**Proposed Biomass Power Station Palings Rd Manjimup
(EPA Assessment 1707)
Connell Wagner addendum to PER 31/03/08**

Stormwater Modelling and Proposed Management Options

Western Australian Biomass Pty Ltd

April 2008

Figure B1: Flow Diagram – Scenario 1 – Reuse of Biomass Area Runoff only

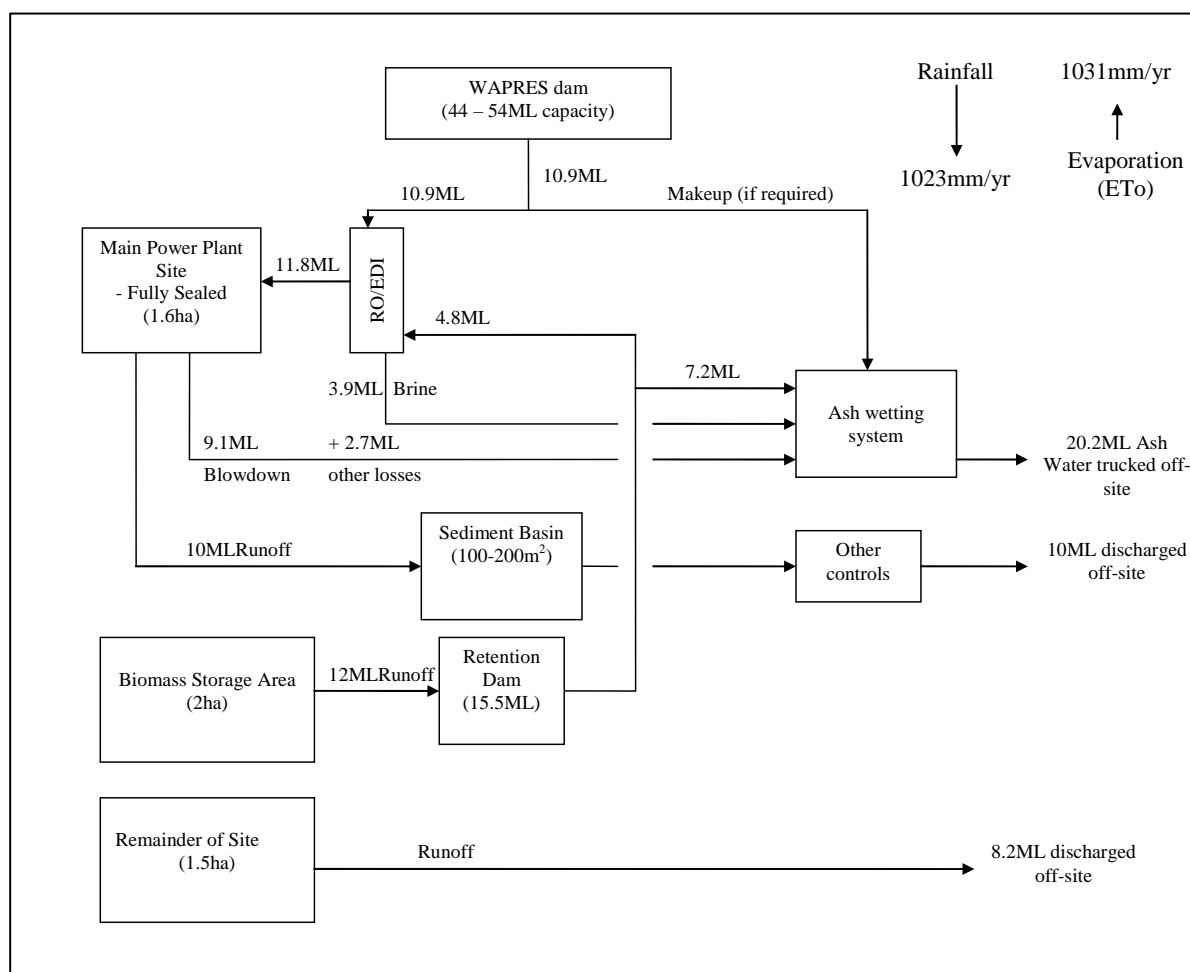
The results of the above water balance based on average climate years has been incorporated into an annual water balance for the site. Two scenarios were explored:

- Scenario 1 - total reuse of biomass runoff water in ash wetting and as input to the plant and discharge followed by treatment of plant runoff water;
- Scenario 2 – as above except incorporating a total reuse of the plant runoff water as well instead of discharge.

Both of the above scenarios involve supplanting WAPRES dam source water and the results, showing estimated annual runoff volumes and reuse volumes, are shown in Figures B1 and B2 in Attachment B.

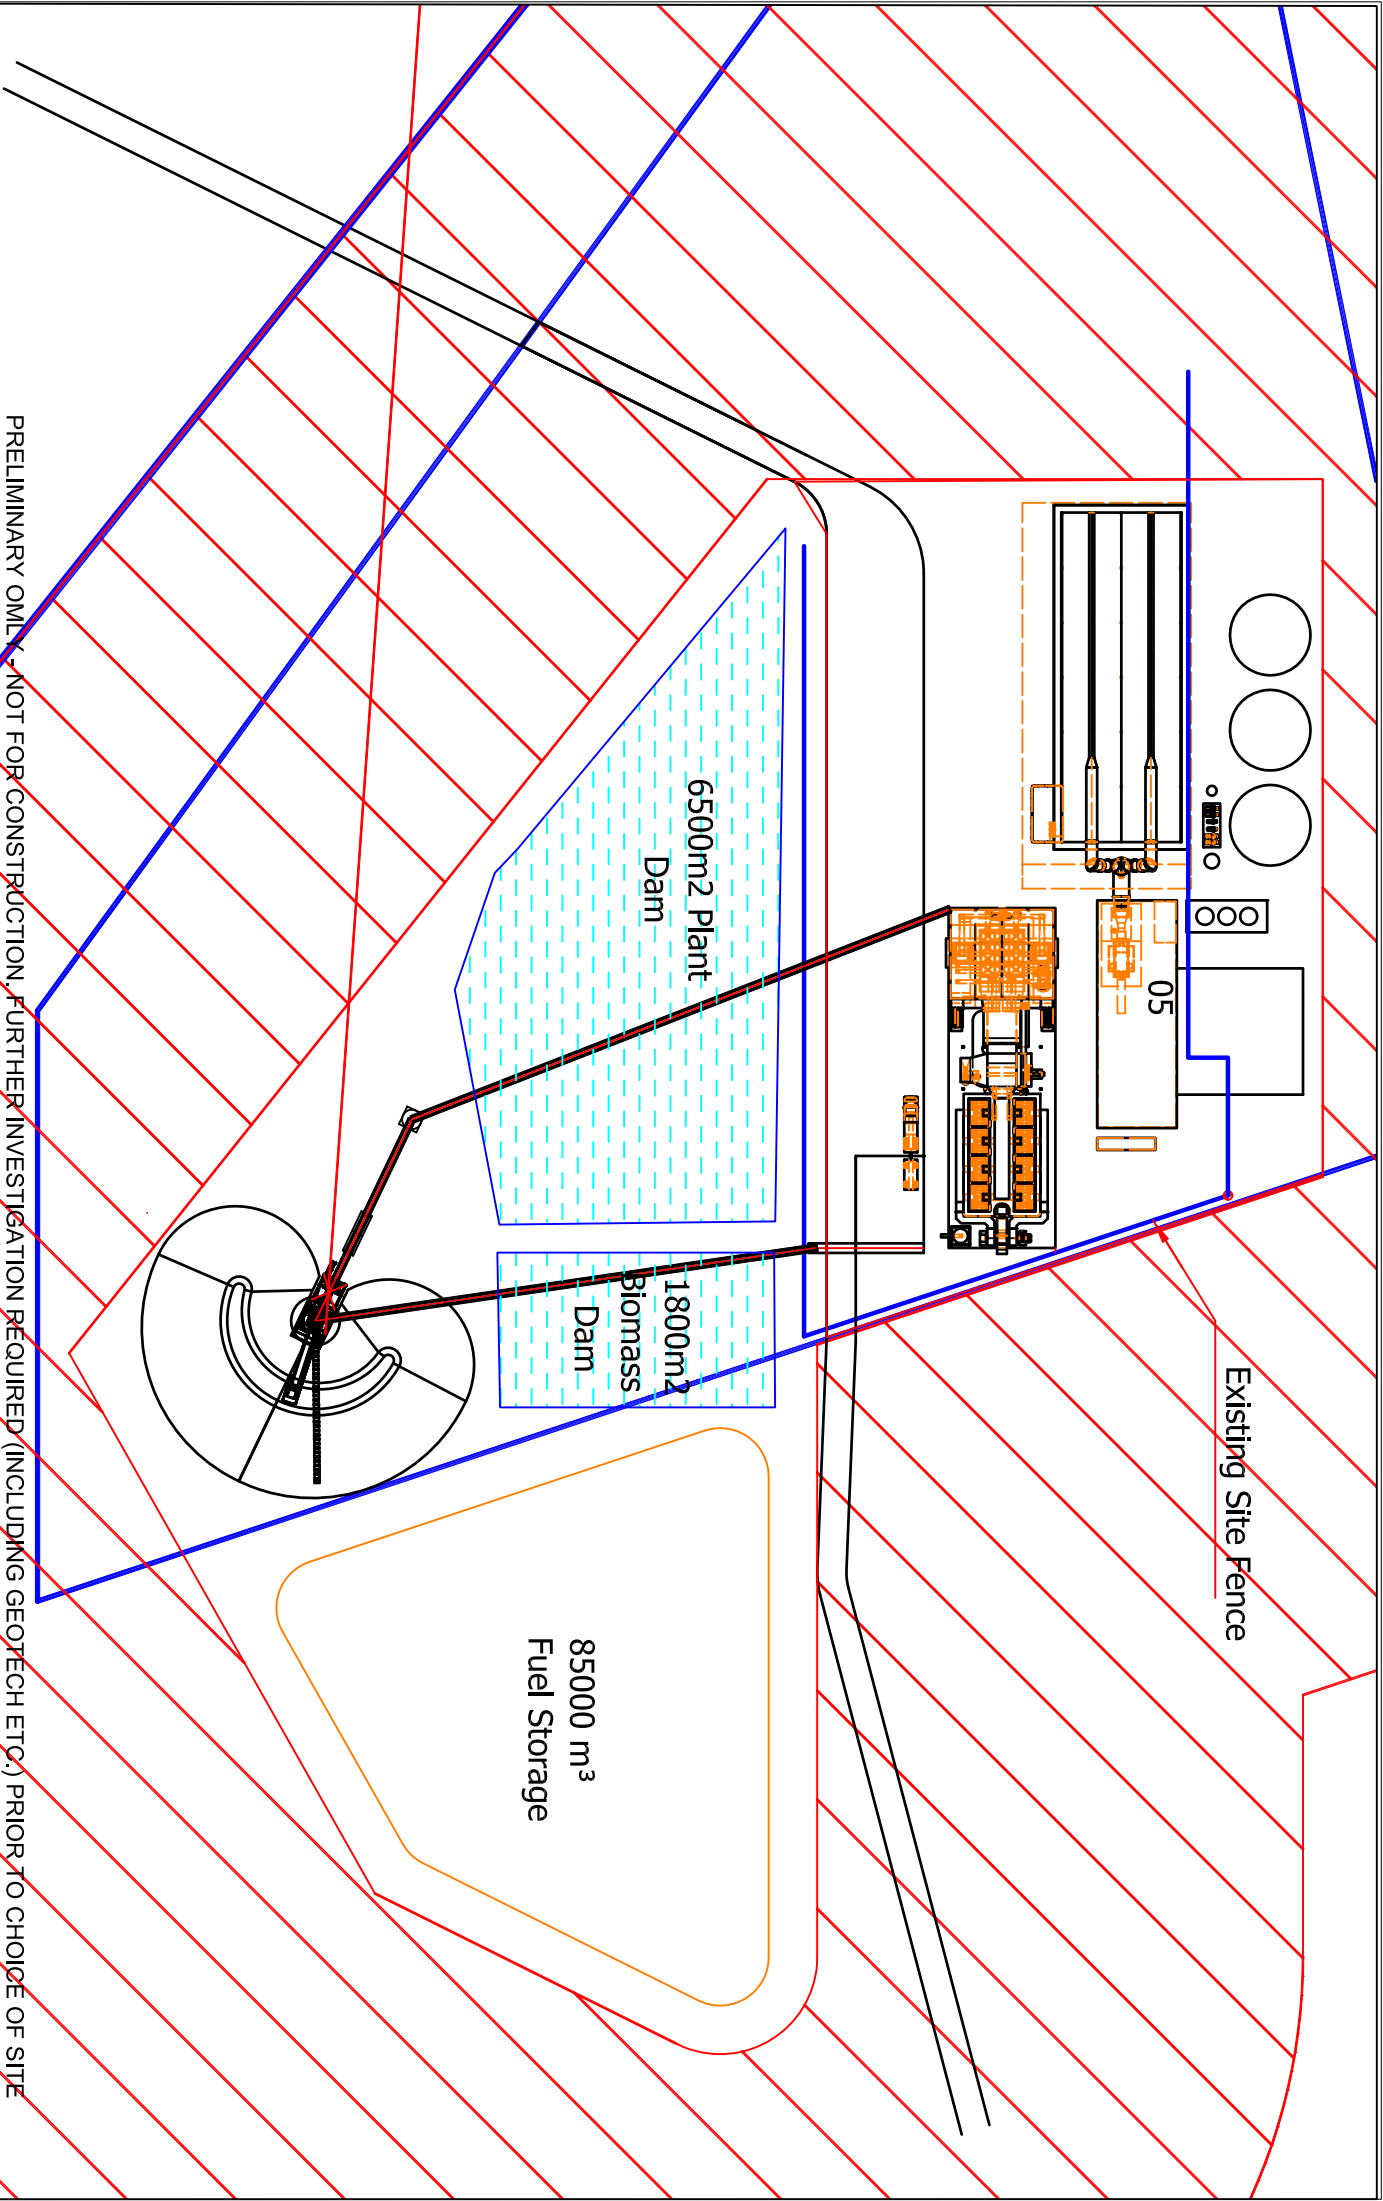
Figures C1 to C3 show some indicative areas that can contain the required pond sizes, chosen to avoid further clearing of vegetation (other than under the feeder belts into the plant). Some difficulties may exist with some of the locations which have not been addressed here. These are therefore preliminary only but do indicate that sufficient space is available without further clearing.
